**PLANNING AND ZONING
BOARD MEETING**

- A.** Elect New Chair and Vice Chair
- B.** Resolution No. 2024-03, Conditional Use Permit- CUP 23-01, by Ronnie LLC for a Concrete Batch Plant within an Industrial (I) Zoning District

Re: CUP 22-00 (Arnold)
Concrete Plant CUP

Response to Comments dated Sept 23, 2022

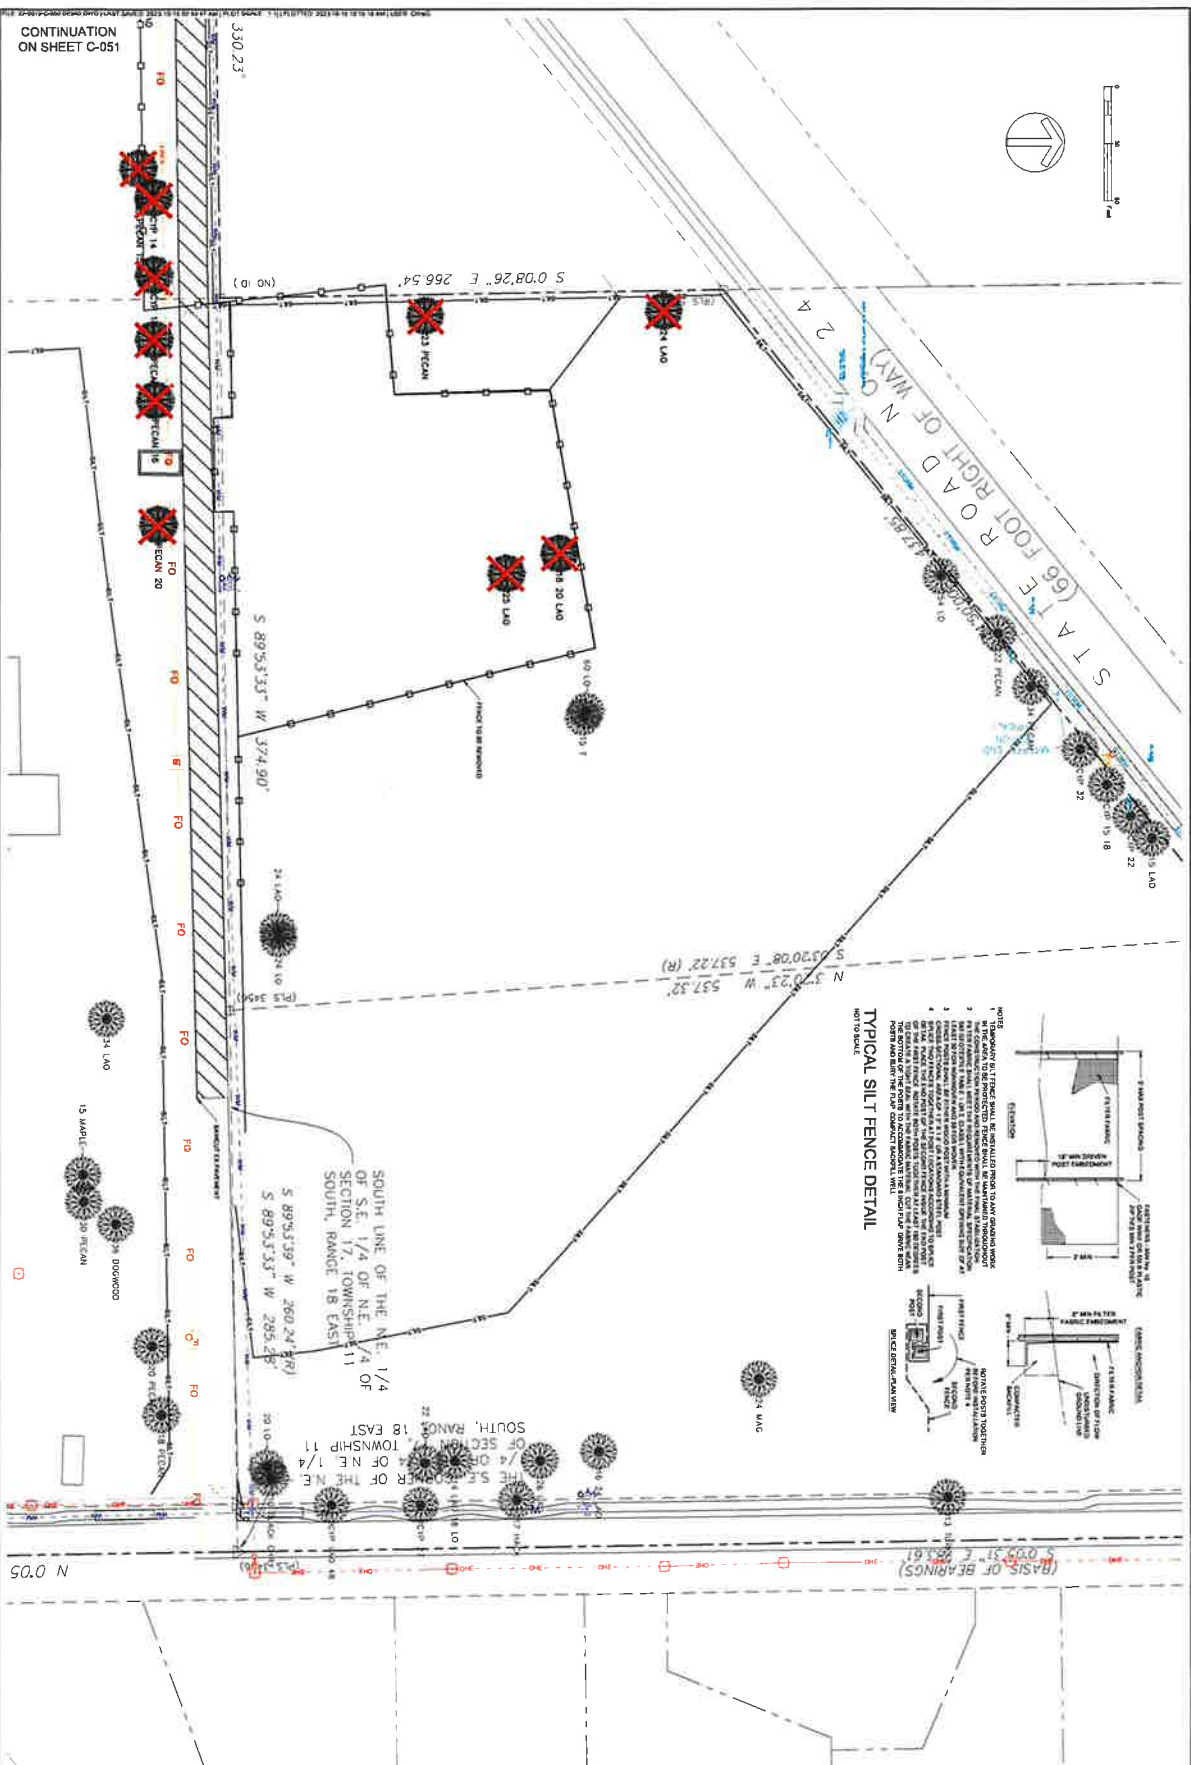
a. The location and identity by common name of all protected trees to be retained and those to be removed. Groups of trees in close proximity (five feet spacing or closer) may be designated as "clusters" with the estimated total number noted. This information shall be summarized in tabular form on the plan; An aerial map of the subject property was submitted with the application showing trees on the property. However, the site plan does not show the location and identity, by common name, of all protected trees to be retained and those to be removed. If any trees will be removed, the applicant needs to update the site plan to summarize this information in tabular form. If no trees will be removed from the site, then so state on the site plan.

See sheet C-051 of the site plans and the landscape plan.

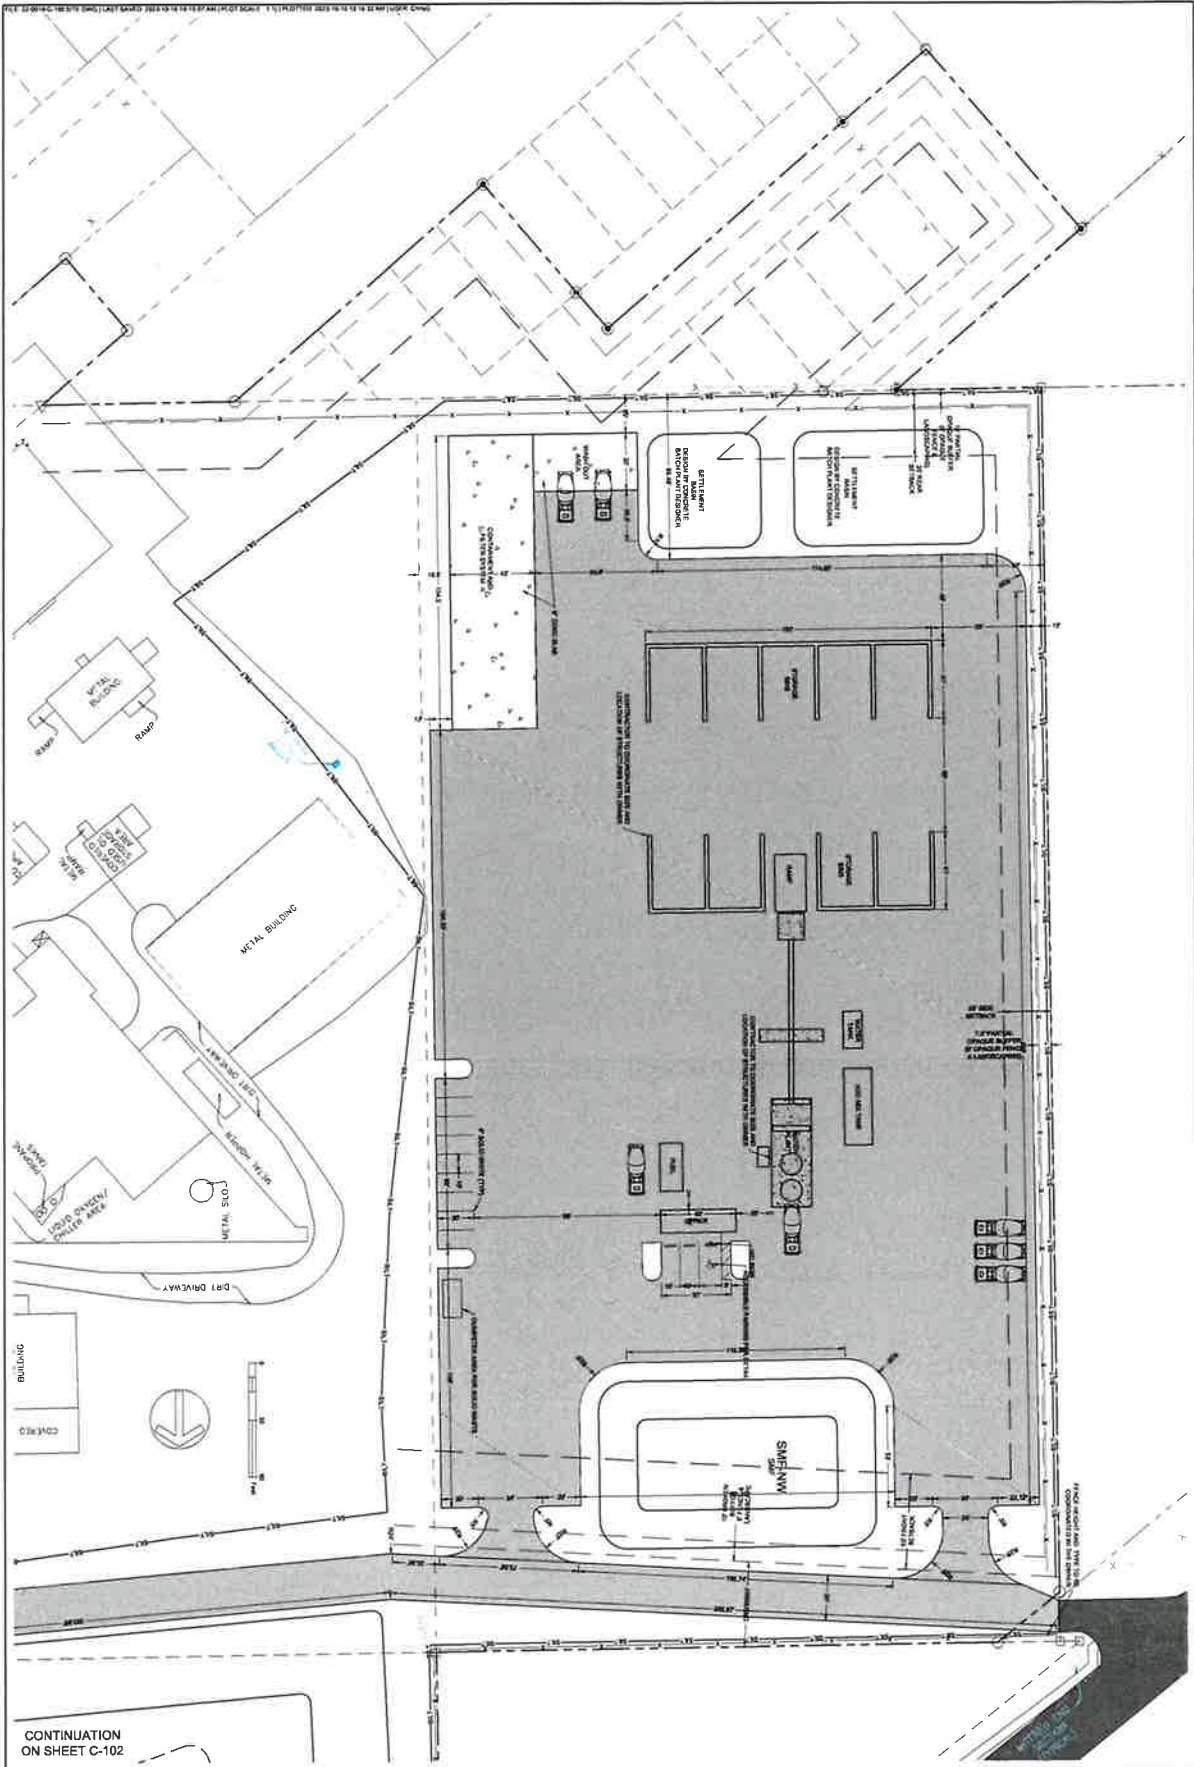
10. Solid waste storage facilities (Section 21.21-23). The site plan does not show the location solid waste storage facilities. The applicant needs to update the site plan to show the location of solid waste storage facilities.

e. Identification of any required landscape buffer areas (Section 21.47) together with a detail of the actual proposed buffer in compliance with Section 21.45. The subject property abuts a parcel to the west that is currently zoned C-2 and, according to Section 21.47 of the Land Development Code, a partially opaque buffer is required in accordance with Section 21.45.2 of the Land Development Code. Also, on the south, the subject property abuts land that is zoned R-2 and, according to Section 21.47 of the Land Development Code, an opaque buffer is required in accordance with Section 21.45.1 of the Land Development Code. The applicant needs to update the site plan to show the required buffers.

See sheet C-101 of the plans for the solid waste dumpster locations.

The buffers along with the setbacks are shown now on Sheet C-101 and the Landscape Plan.
